The staff confirmatory analysis shows that the APR1400 synthetic acceleration time histories envelop the CSDRS for all specified damping values based on the SRP 3.7.1, Rev. 4, Option 1, Approach 1 criteria. The staff confirmatory analysis also shows that the power spectral density (PSD) functions of these time histories are higher in the frequency range of interest than 70% of the target PSDs developed by the staff, using strong motion durations defined as the duration of near maximum and nearly stationary power of an acceleration time history record. The target PSDs were developed following the SRP 3.7.1 Rev. 4, Appendix B procedure.

KHNP INPUT

Figure 1 Fourier Spectra for TH in the EW Direction

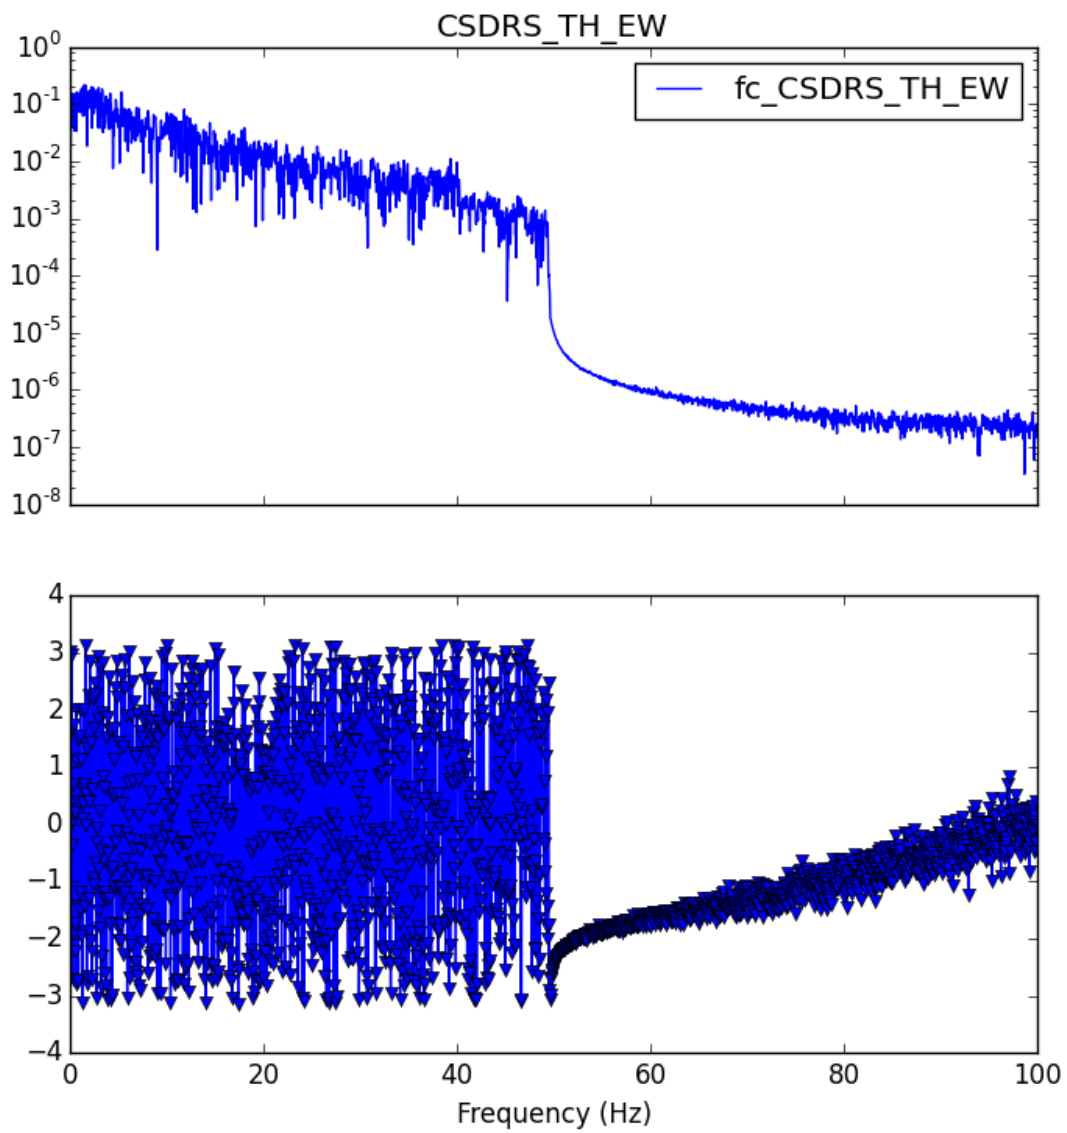
However, the Fourier spectra of the time histories show evidence of low pass filtering with corner frequencies lower than 50 Hz, as shown in the figures below. The issue is more evident in the NS direction, with a corner frequency around 48 Hz. The gaps between the corner frequencies and 50 Hz are small so the effect of filtering out the input motion components between the corner frequency and 50 Hz may not be great. However, an evaluation of this effect can lead to higher confidence in the validity of these time histories. Therefore, the staff requests the applicant to explain why filtering was needed in the development of the synthetic acceleration time histories and develop some justification so that this issue can be discussed during the audit.

In the development of synthetic acceleration time histories to match the APR1400 CSDRS of multiple damping values, a low-pass filter was applied to the time histories because the baseline correction and/or clipping of time history that were performed during the spectrum-matching process introduces artificial high-frequency motion contents in the modified time histories. The upper-frequency value of the low-pass filter near 50 Hz was chosen because 50 Hz was the cut-off frequency of the APR1400 CSDRS. The actual upper-frequency value chosen for the low-pass filter was 48 Hz for the NS component, 49.5 Hz for the EW component, and 48.5 Hz for the vertical component of the synthetic acceleration time history. There was no particular reason for selecting the specific upper-frequency values of the low-pass filter as indicated above. The values chosen produced good results in the response-spectrum matching in the high frequency range near and above 50 Hz. If the above-mentioned low-pass filter was not used, the modified time history generated would have time-history response spectrum values that would not match and converge to the PGA value in the frequency range equal to and higher than 50 Hz.

The response-spectrum-compatible synthetic acceleration time histories generated satisfy the SRP 3.7.1, Rev. 4, Option 1, Approach 1 response-spectrum enveloping criteria for the frequency range from 0.2 to 50 Hz. The power spectral density functions (PSDs) computed from the generated synthetic acceleration time histories envelop, over the frequency range from 0.3 to 50 Hz, the minimum-required (80%) target PSDs compatible with the CSDRS developed following the guidelines and procedures provided in the SRP 3.7.1, Rev. 4, Appendix A, for the low frequency range from 0.3 to 9 Hz and following the time-history simulation method described in NUREG/CR-5347 for the high frequency range from 9 to 50 Hz.

The average PSD which is smoothed over a frequency band width of ± 20 percent, centered on the frequency, will help to smooth out any PSD gap between 48 Hz to 50 Hz. In addition, due to the band width of the response transfer function of the SDOF system at and near 50 Hz, the spectral response between 48 Hz to 50 Hz shows adequate spectral response amplitude in this frequency range as indicated by the time history response spectra matching the target response spectral values.
